Sizewell C

Environmental Impact Assessment

Expert Statement

REPORT
REP-0743

Figure 1:
Land projected to be below annual flood level in 2050 around Sizewell C site.

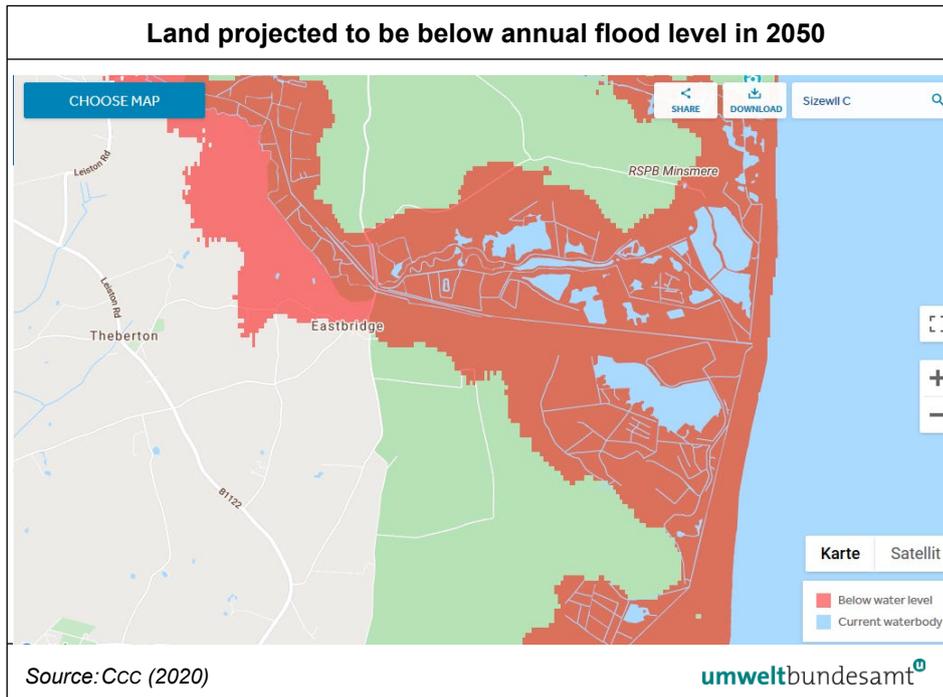
The Sizewell C site is prone to flooding events. This is illustrated by the following pictures, created by the Coastal Risk Screening Tool, which illustrates the land projected to be below the annual flood level in 2050. The Climate central sea-level maps are based on peer-reviewed science in leading journals. Improved elevation data indicate far greater global threats from sea level rise and coastal flooding than previously assumed. (CCC 2020)

Site-specific factors (in particular possible danger of flooding, climate change effects) could endanger Sizewell C. Flooding can be catastrophic consequences for a nuclear power plant. The EIA documents explain that a detailed assessment of site-specific nuclear safety and security risks would be undertaken as part of the nuclear site licensing regime. The authorities accepted that with this regulatory process in place regarding the safety of the UK EPR™ reactors and the EIA does not need to present a detailed assessment of nuclear safety risks.

5. *Which recent national and international studies concerning external hazards (flooding risk, seismic hazard, tsunami and climate change) have to be taken into consideration to determine design basis requirements? Which margins against external hazards have to be implemented for the Sizewell C?*

Figure 2:
 Deposition of Cs-137
 after a severe accident
 at the Sizewell site,
 weather situation of 10
 Jan 1995.

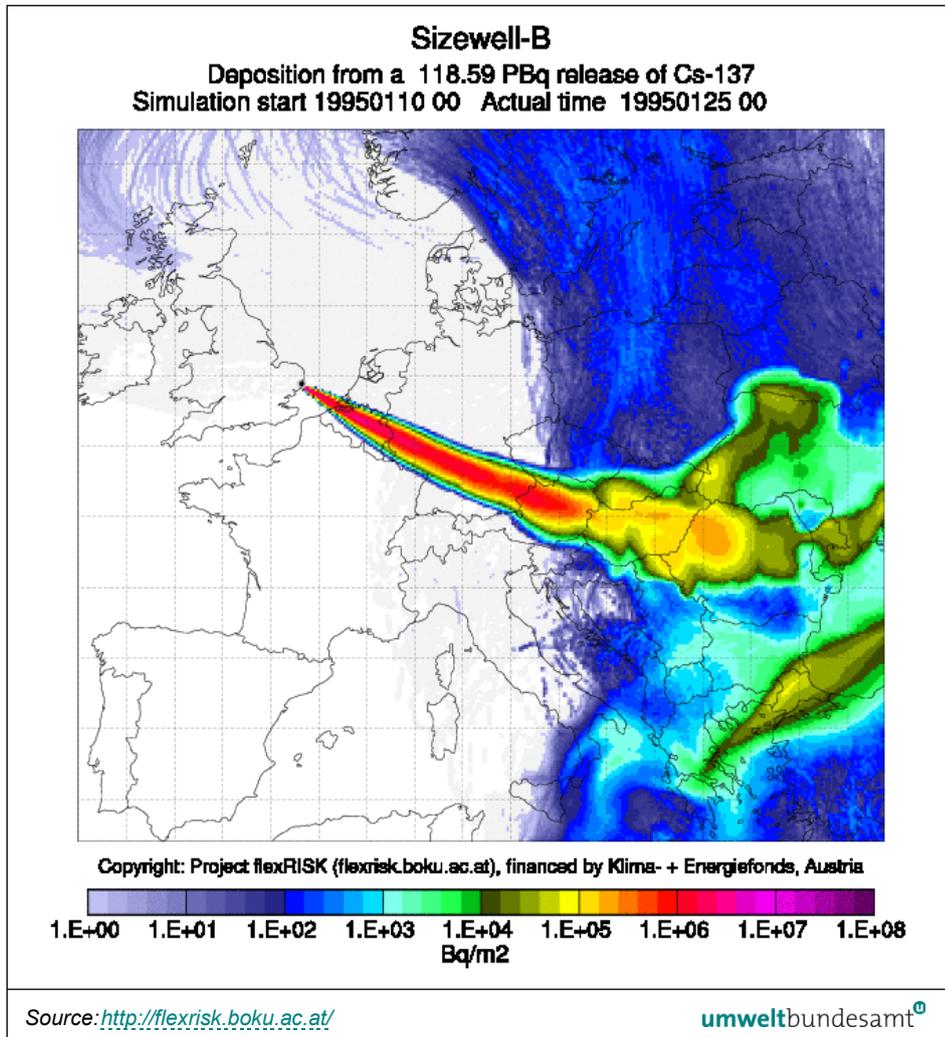
Under weather conditions similar to those on 10 Jan 1995, large parts of the territory of Austria would be significantly affected by an accident at the Sizewell site. Contaminations in Austria could reach up to a few 100 kBq Cs-137/m² (orange and red scale, up to 1E+06 Bq/m² = 1,000 kBq/m²).

Contaminations of several 100 kBq Cs-137/m² like in figure 2 or 3 are much higher than these levels, therefore agricultural countermeasures could be necessary on Austrian territory in case of a severe accident at the Sizewell site; Austria would be severely affected.

Figure 4:
 Integrated concentration of I-131 from a severe accident at the Sizewell site, weather situation of 6 Nov 1995.

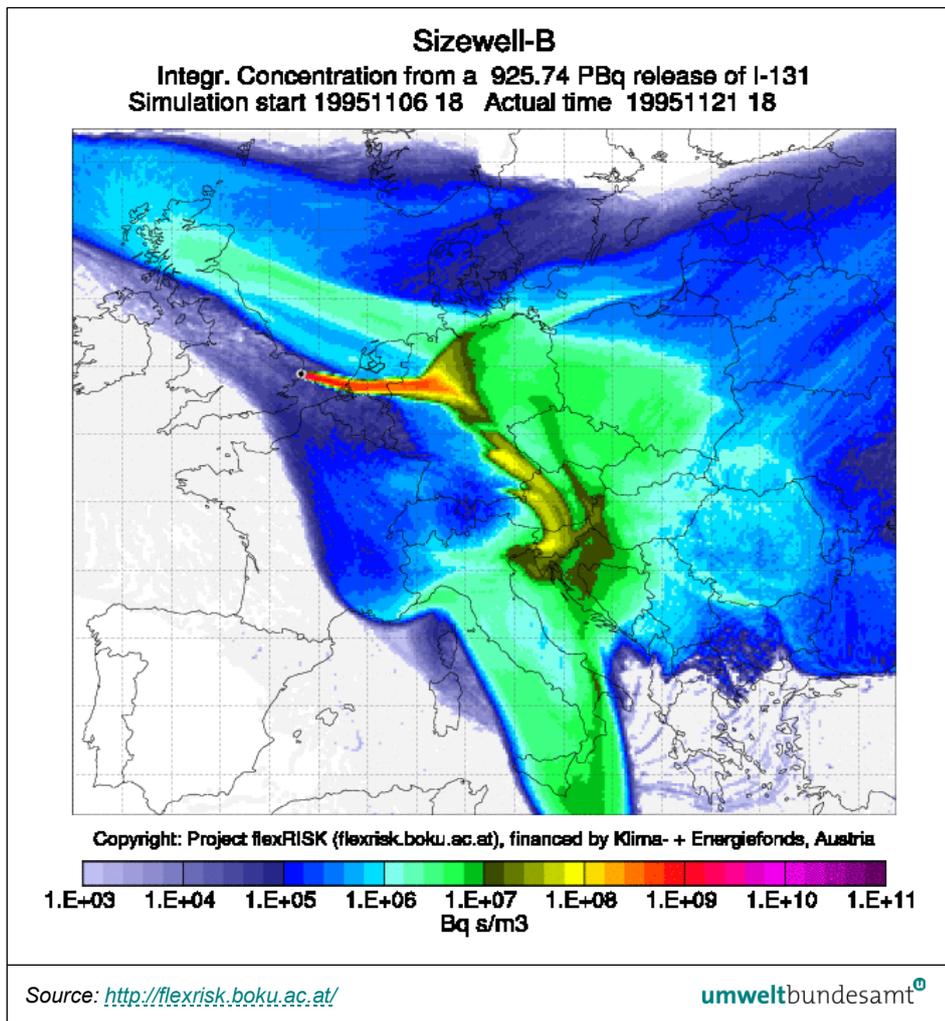
Figure 4 shows a meteorological scenario for I-131. The highest concentration on Austrian territory can be up to several 1,000 Bq h/m³. Also this concentration is far above the above mentioned level which requires the start of agricultural countermeasures in Austria.

Figure 5:
Possible thyroid dose for infants for a weather situation like on 6 June 1995; maximum dose for 7 days in Austria is 25.67 mSv.

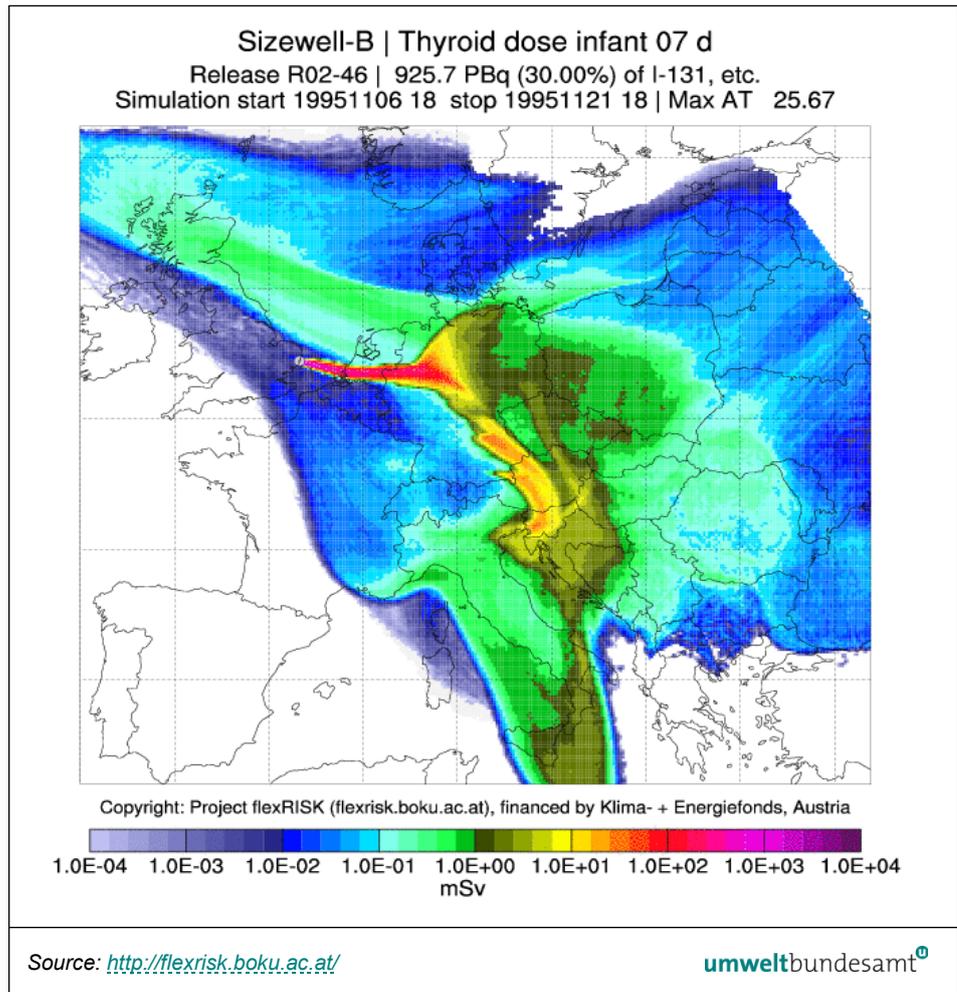
Figure 5 shows the maximum thyroid dose for infants resulting from an I-131 release in a weather situation like on 6 June 1995. Up to 25.67 mSv could be expected in 7 days. This could result in the intervention measure of iodine prophylaxis for risk groups.

Figure 6:
 Weather-related probability for a deposition of >185 kBq Cs-137/m² due to a severe accident at the Sizewell site.

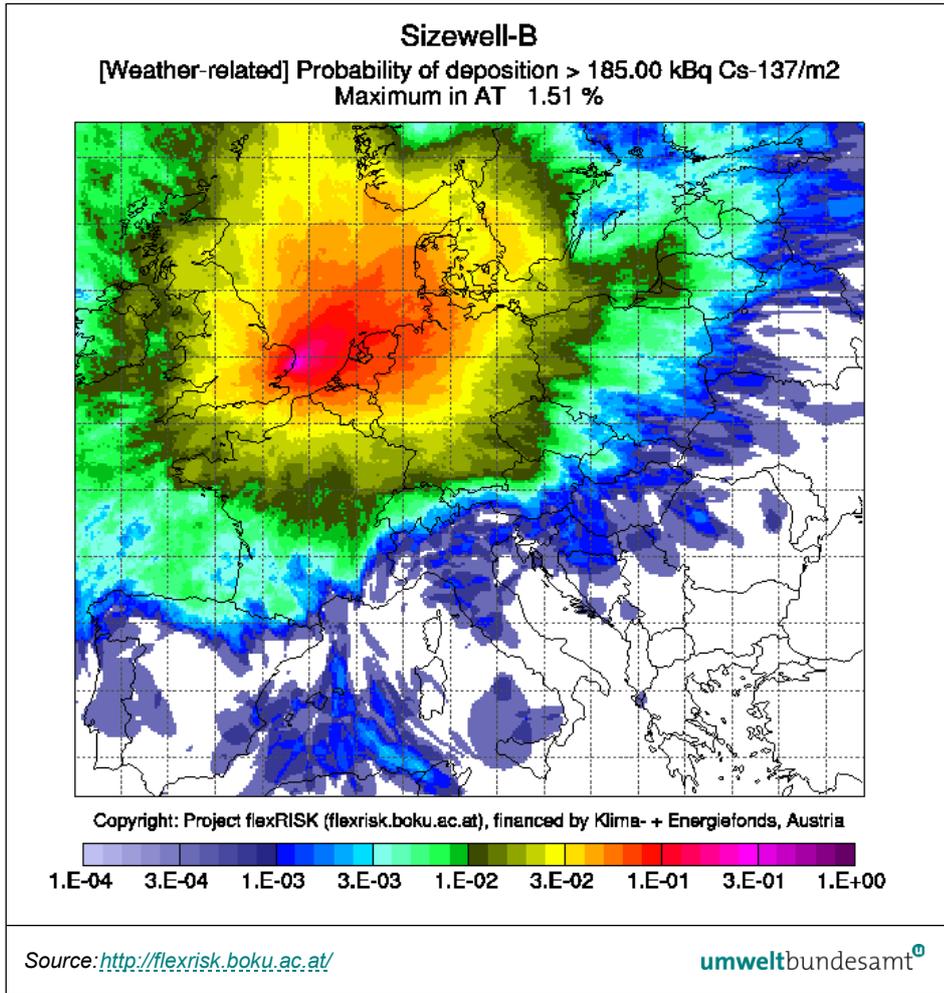
When summarizing the weather-related probability of Austria being contaminated with more than 150 kBq Cs-137/m² by a severe accident in Sizewell, a maximum probability of 1.51% is calculated (see figure 6). Such a contamination would be comparable to the highest contaminations that occurred in Austria after Chernobyl (186 kBq Cs-137/m²).
